TT403: 2009 Sidecar Battery Tray Fitment

March 26, 2009

2009 Sidecar Battery Tray Fitment

Figure 1. Battery Tray For Bank Angle Sensor

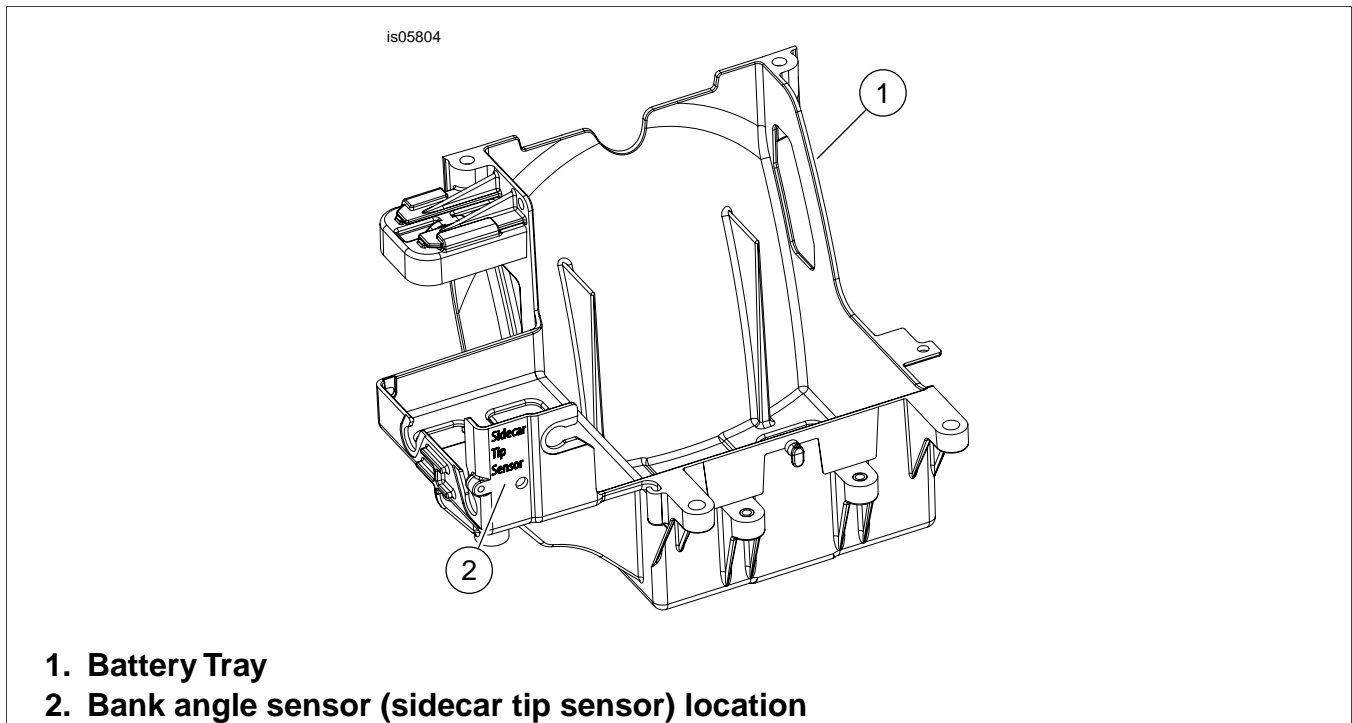
The later battery tray can be identified by the words "sidecar tip sensor" in the location shown in Figure 1 below.

If the words "sidecar tip sensor" do not appear as shown in figure 1, the tray is an early version that must be changed before a sidecar installation may be completed.

Early 2009 FL motorcycles that will have a sidecar installed require a new battery tray (part number 66281-09A or later revision) for proper bank angle sensor mounting.
